Flood Damage Reduction Segment / System Inspection Report

Name of Segment / System: Alameda Creek FFCP Left Bank ALLB

Flood Damage Reduction Segment / System
Inspection Report
Alameda Creek FFCP Left Bank ALLB

Inspect ID: ALLB_2018_a_0011 **Title:** USACE_CESPN_ALLB_2018_a_0011_1.jpg
Rated Item: 10. Sluice/ Slide Gates **Caption:** Rating: Acceptable; Remarks: NA;
Action: NA; Station_1: 292+00

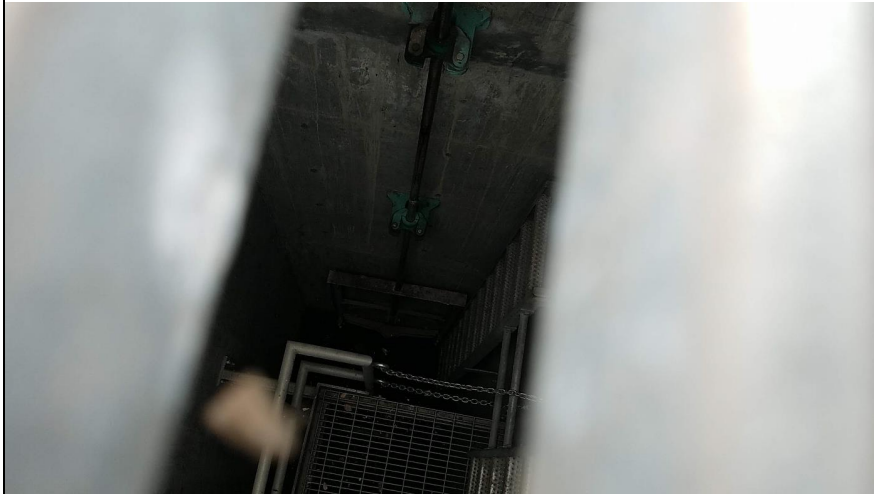
Inspect ID: ALLB_2018_a_0011 **Title:** USACE_CESPN_ALLB_2018_a_0011_2.jpg
Rated Item: 10. Sluice/ Slide Gates **Caption:** Rating: Acceptable; Remarks: NA;
Action: NA; Station_1: 292+00
